GTS Newsletter

2009/09E

Machine	TASKI swingo XP
Subassembly	Base

Linear drive Brush unit

Modification kit Chassis/Brush unit

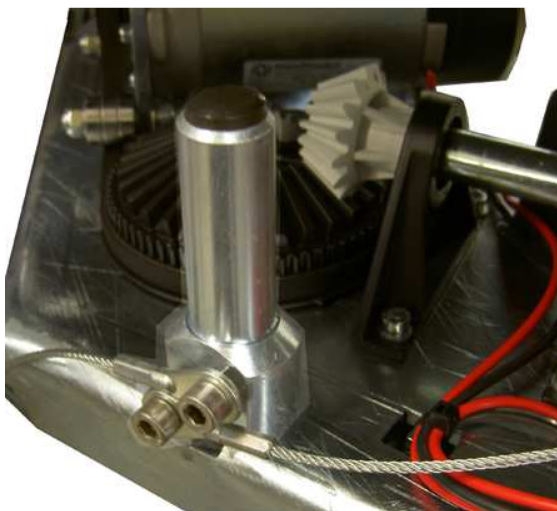
Due to an increasing number of linear drive orders, as well as feedback from the field regarding broken fork heads, we introduced a modification kit for the chassis/brush unit. Additionally the fork head is now available as single spare part.

4 holes, Ø 7mm (according drawing) have to be drilled into the chassis to complete modification.

The fixations of the new parts have to be secured with thread locker 4017370 (8936/1).

Description	Order Number	Quantity [pcs.]	Remark
Stop	4128772 (18603-64)	1	New spare part
Counters.Hd.Cap Screw M 6x20	4042550 (1292/25)	4	
Washer 6/20	4019790 (1752/15)	4	
Self-Locking Nut M 6	4092870 (1721/106)	4

Guidance bolt fixed to motor base plate

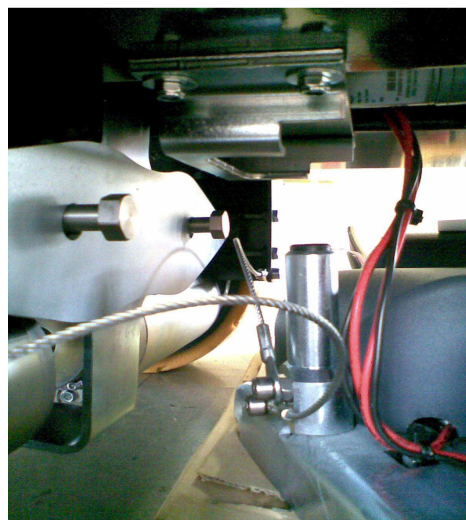
To assemble the bolt on the motor base plate the original hole has to be enlarged up to 11 mm.

Description	Order Number	Quantity [pcs.]	Remark
Bolt	4128771 (18603-63)	1	New spare part
Stopple 20	4124204 (3061/222)	1	
1752/16 Washer 10,5/21	4027970 (1752/16)	1	
Socket Head Cap Screw M 10x20	4042610 (1132/41)	1

Fork head

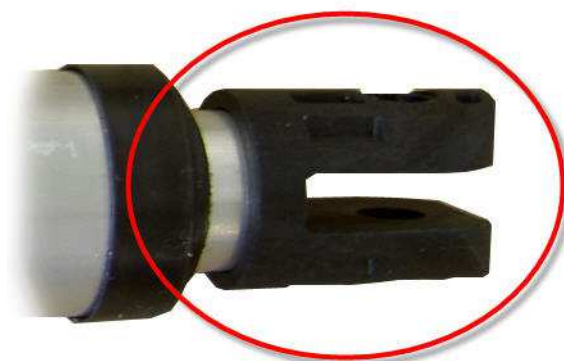
Description	Order Number	Remark
Fork head	4128739 (18603-58)	New spare part
